# THE GLEN AT WIDEFIELD SUBDIVISION FILING NO. 7A

A replat of lots 52 through 55, 93 and 94, The Glen at Widefield Subdivision No. 7 Located in a portion of the Northwest One-quarter (NW1/4) of Section 27 Township 15 South (T15S), Range 65 West (R65W) of the 6TH P.M. County of El Paso, State of Colorado

PCD FILE NO. VR1812

THE GLEN AT WIDEFIELD SUBDIVISION FILING NO.7A

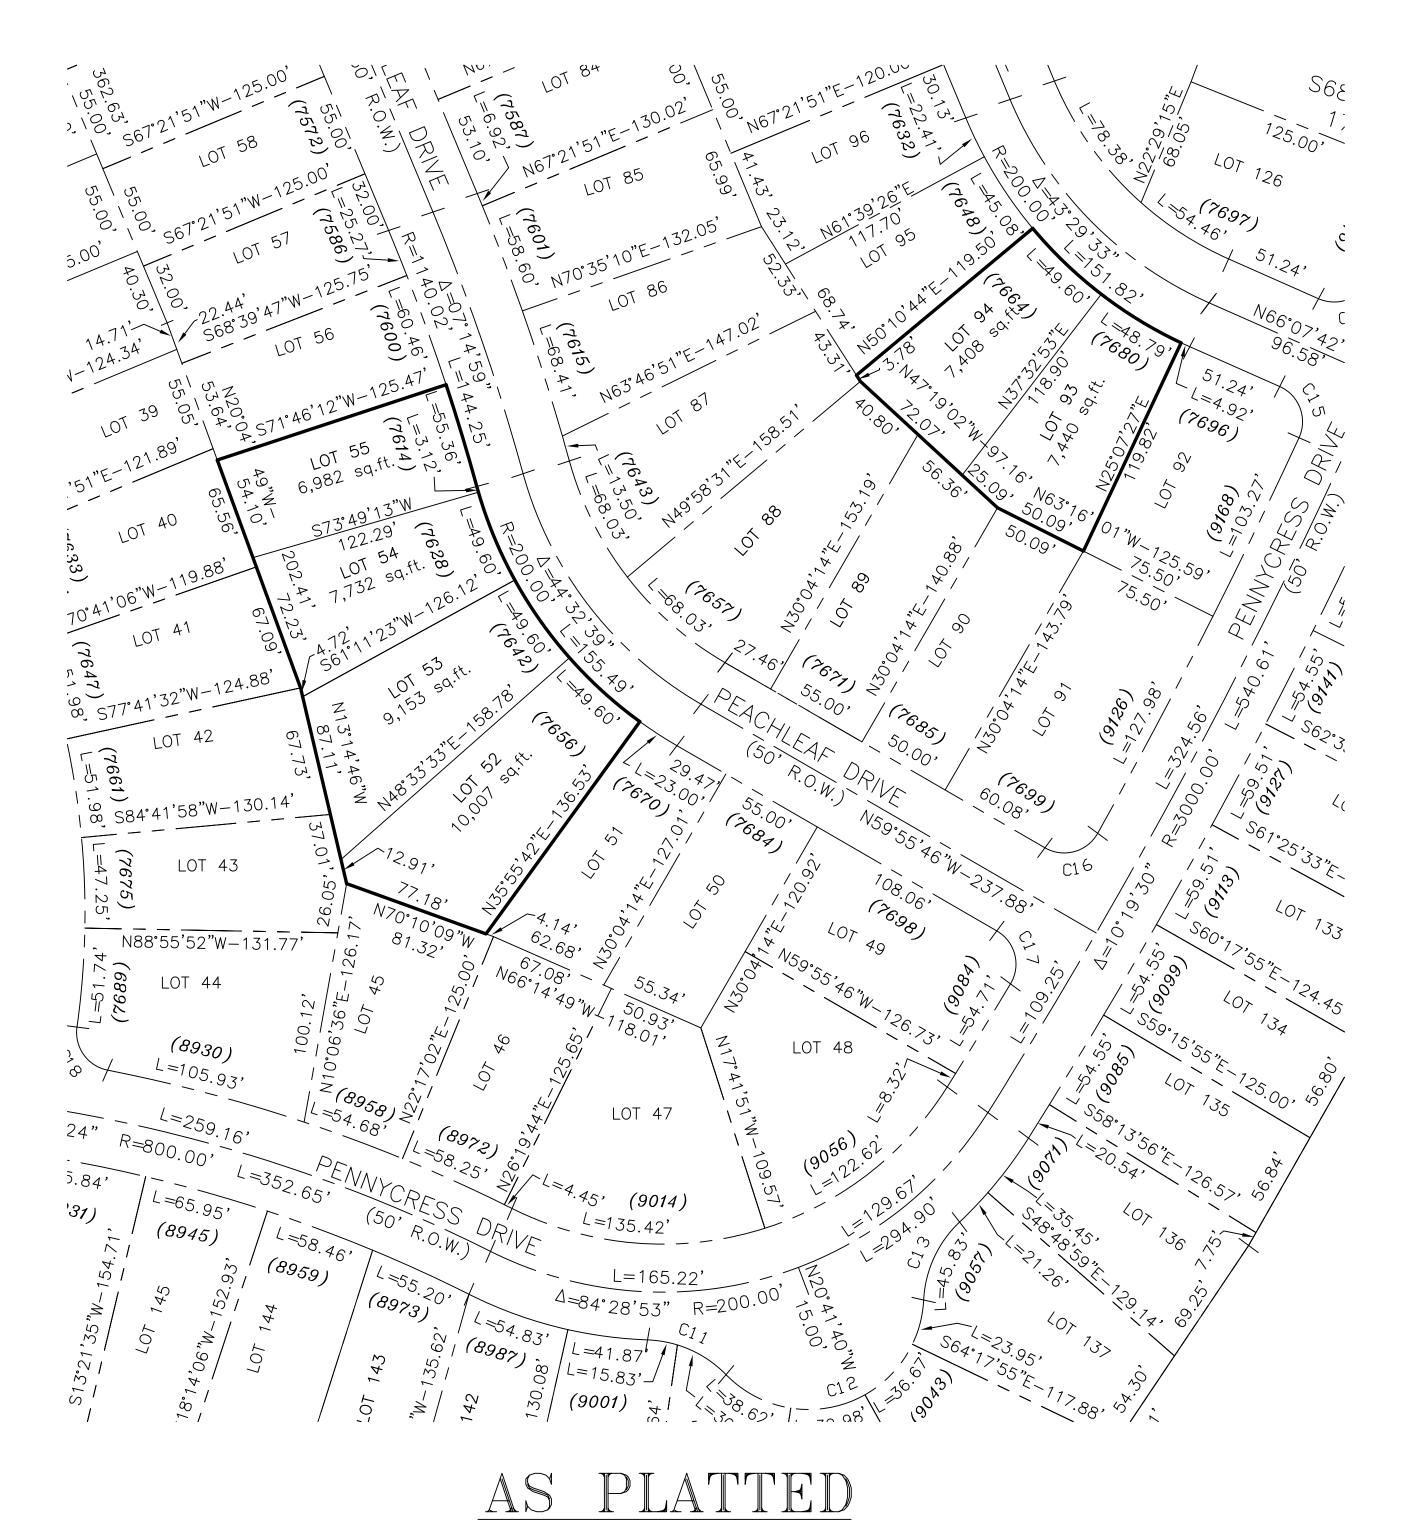
This isn't ne	ecessary,
		the Board o	•
		Commissio	
		not be sign plat.	
	APPROVALS:	piati.	
	The accompanying plat was approved by Community Development this de		l ,
			_
_	Director, County Planning and Community	Development	
	POARD OF COUNTY COMMISSI	ONEDO OE

This isn't necessary, the Board of County Commissioners will not be signing this

plat

vacation and replat

vacation and replat
